UKPCS-003

Approval Drawings

ICF general arrangements, steel over ICF, elevations, sections

Icf Homes - Dendrons

DRAWING TITLE
GF ICF GENERAL ARRANGEMENT
ICF walls, openings and setting out

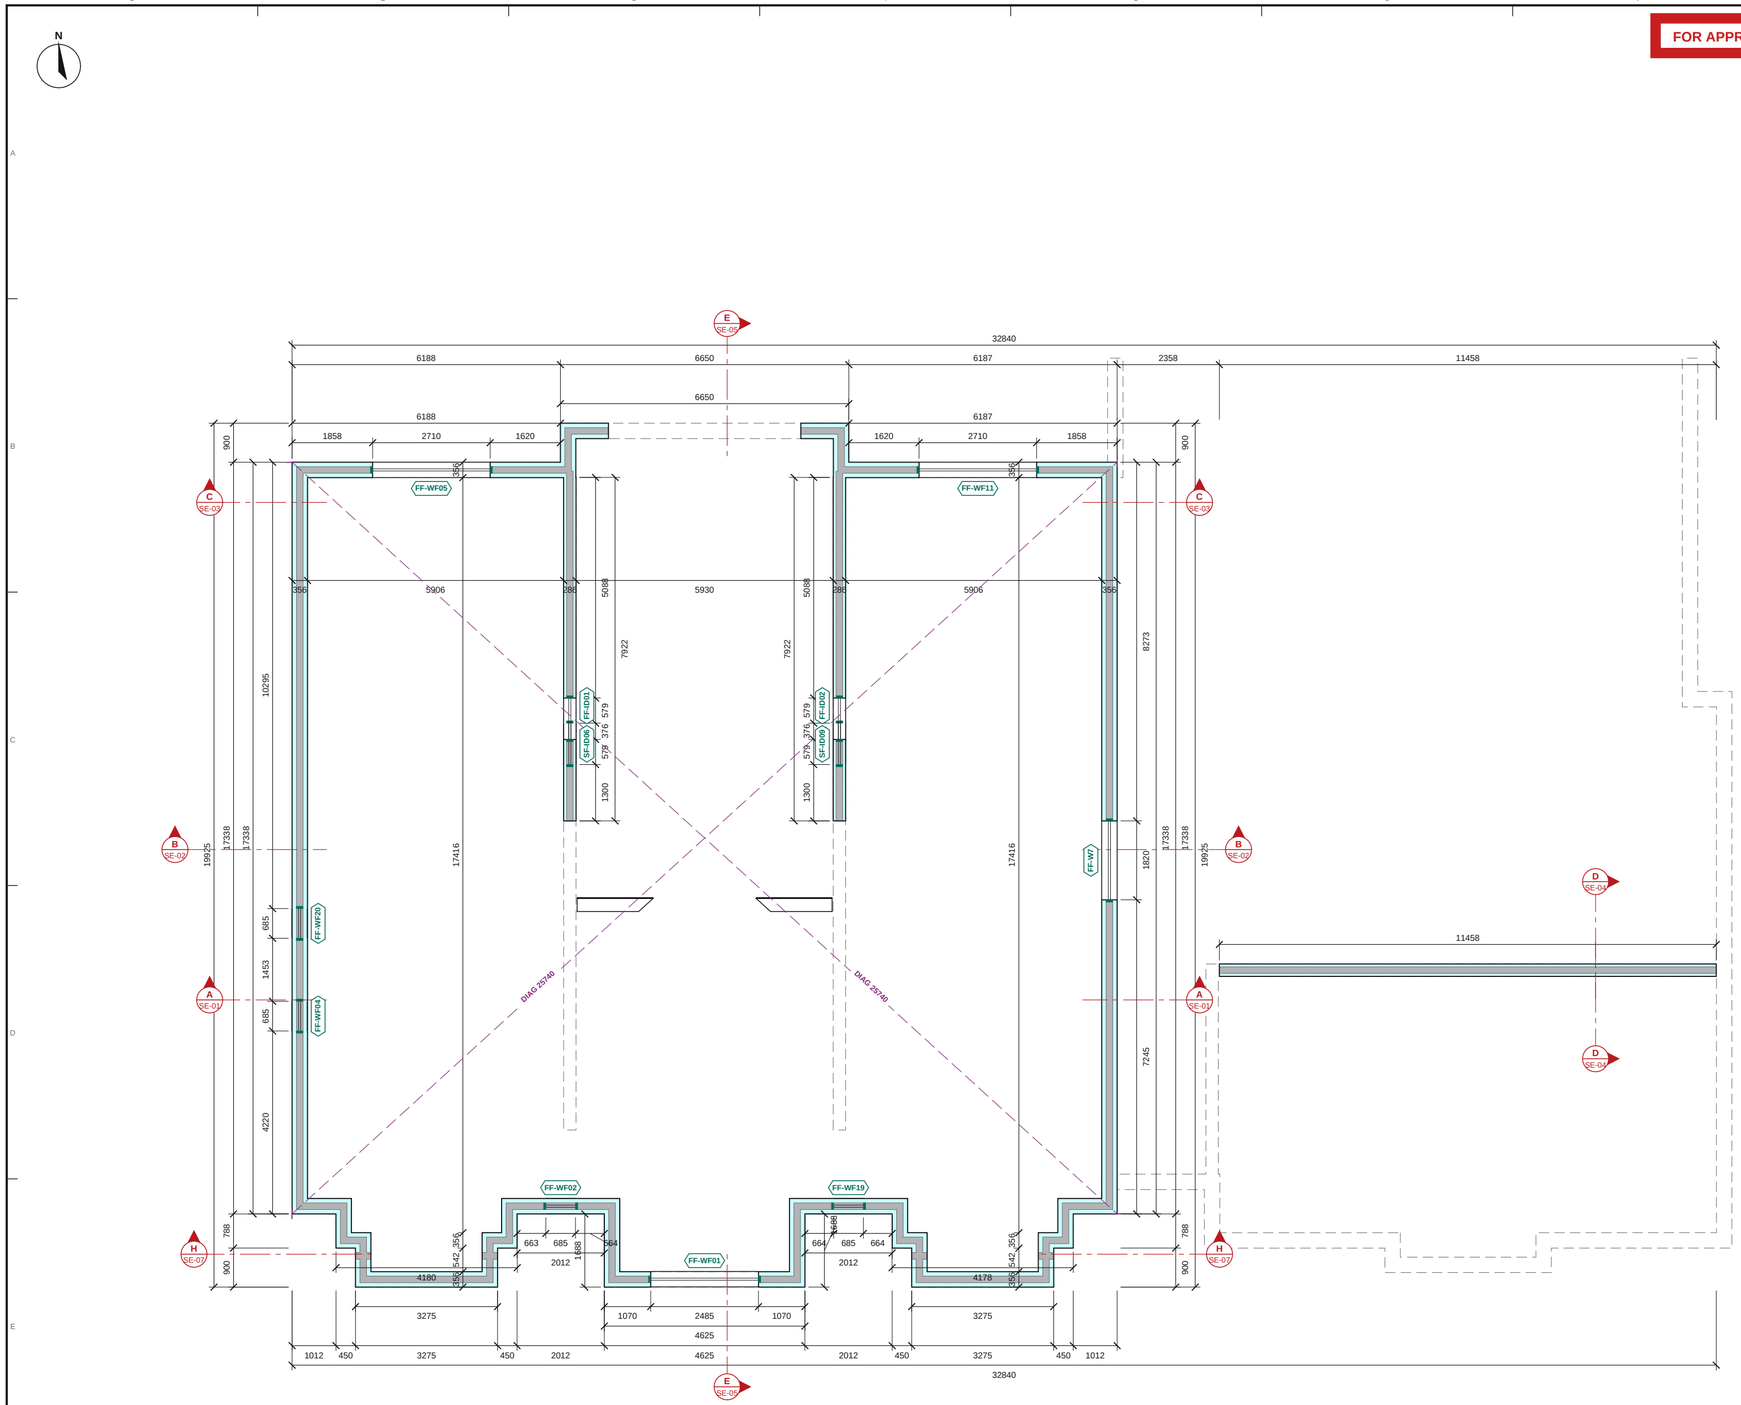
1. P03 revises the P02 approval issue (16.10.26) to Chris Yeates' comments of 16.10.26 and his opening schedule: GF internal door heads 2700, FF-ID01/02 heads 5850, FF-WF01 sill 3900 / head 6150, the north bay screen sill dropped to +3425 with its arch raised 75 mm, and the first-floor void W7 made an opening (3350-5850) with an ICF lintel.

Structural openings in the ICF; sill and head above GF FFL. (1) GF-WG10: frame head 2825; ICF starts on the steel, outer ICF skin carried down over the steel and slab edge to the frame head (also WG11-13 and the GF bay voids) VOID = subtract cut in the ICF (no end caps / lintel buck modelled).

NORTH AND SOUTH ELEVATIONS

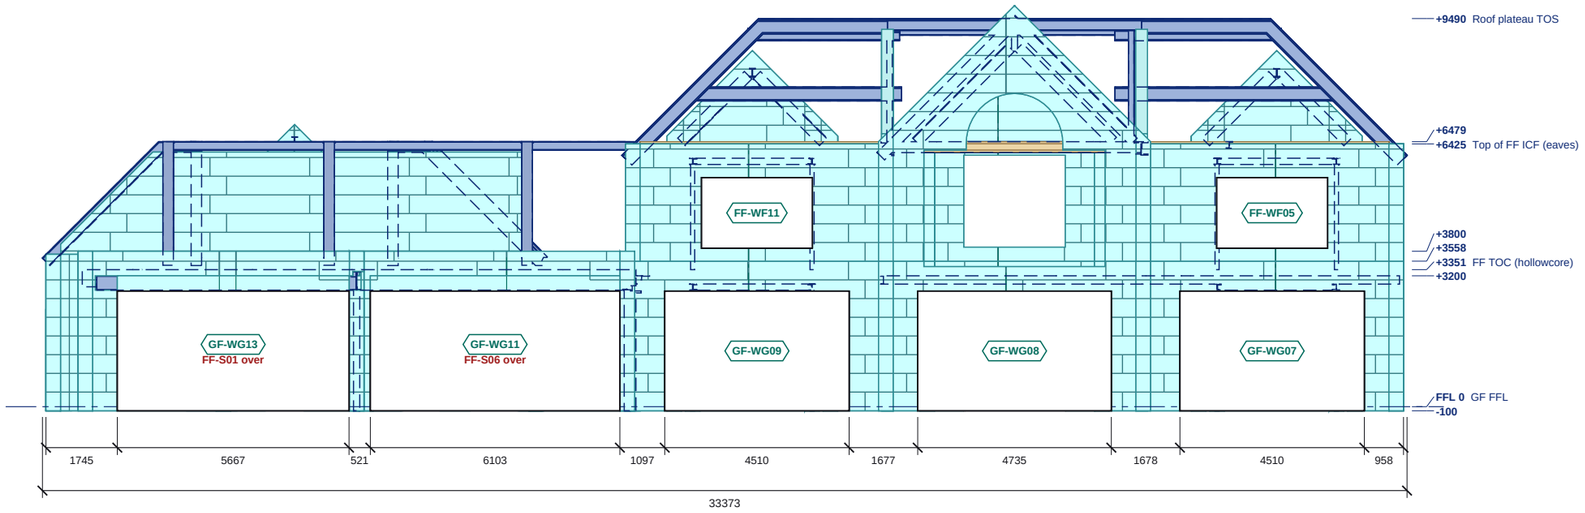
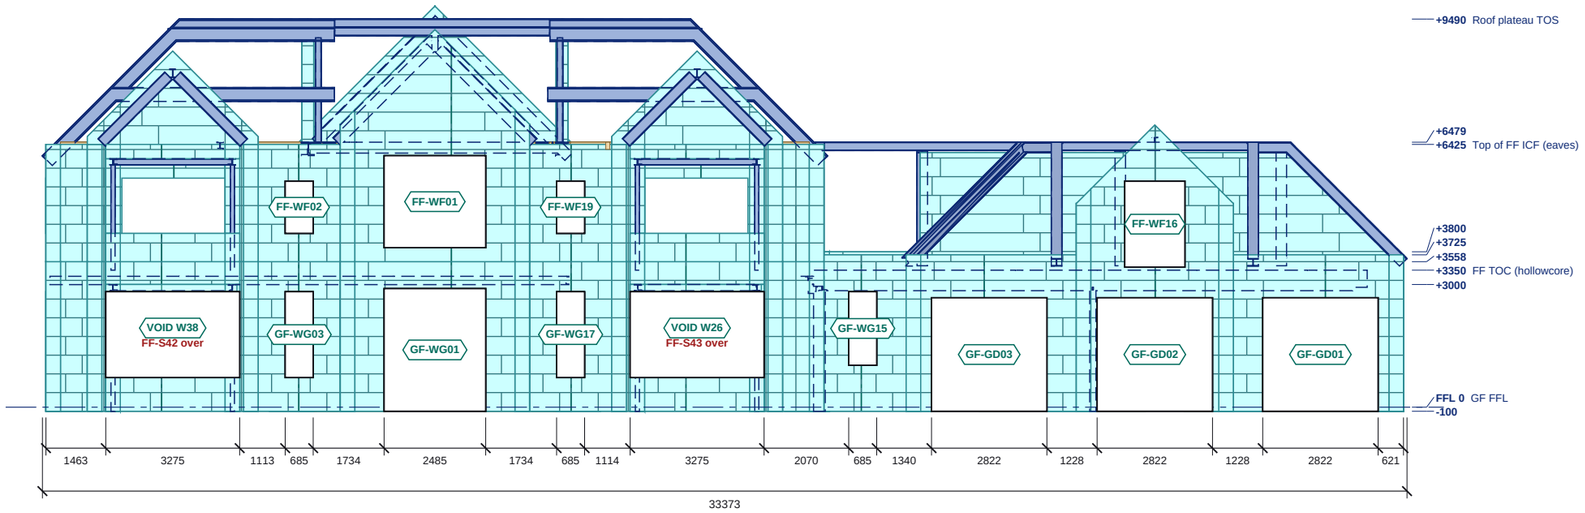
3. The "+3558" level on the P02 elevations was the north bay sill step at the GF/FF ICF joint; it no longer applies.
4. Steel is sized to the architect's 16.10 schedule: 18 members re-sized, and RF-S29, S30, S35, S36, S37 a/b, RF-S39, RF-S40/41, the FF-S05/S11/S50/S51 shelf angles and the SF-P01/02/05/06 posts added, set to the schedule tops of steel (positions from the engineer's GAs). RF-S33 (no section on the schedule) and SF-S02 are queried. Pockets are site-cut to the pocket schedule.

WEST ELEVATION

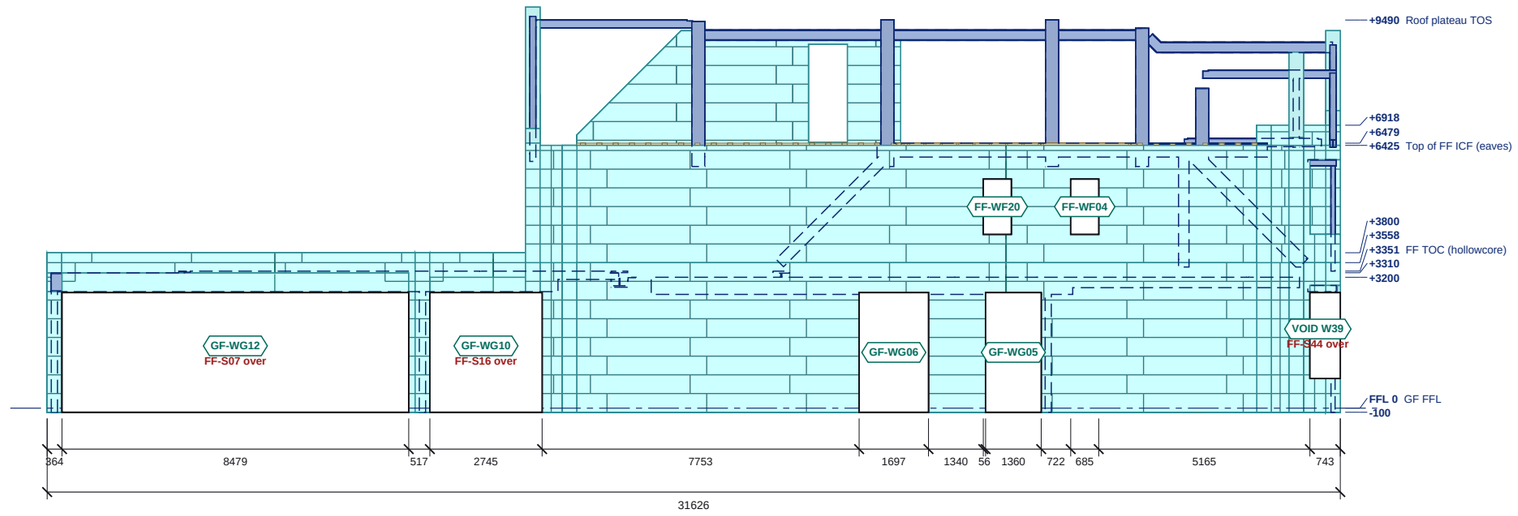
2. GF-WG10 to WG13 and the GF bay windows: frame heads at 2825. The ICF starts on the steel above; the outer ICF insulation skin is carried down over the steel and the slab edge to the frame head.

Structural openings in the ICF; sill and head above GF FFL. (1) GF-WG10: frame head 2825; ICF starts on the steel, outer ICF skin carried down over the steel and slab edge to the frame head (also WG11-13 and the GF bay voids)
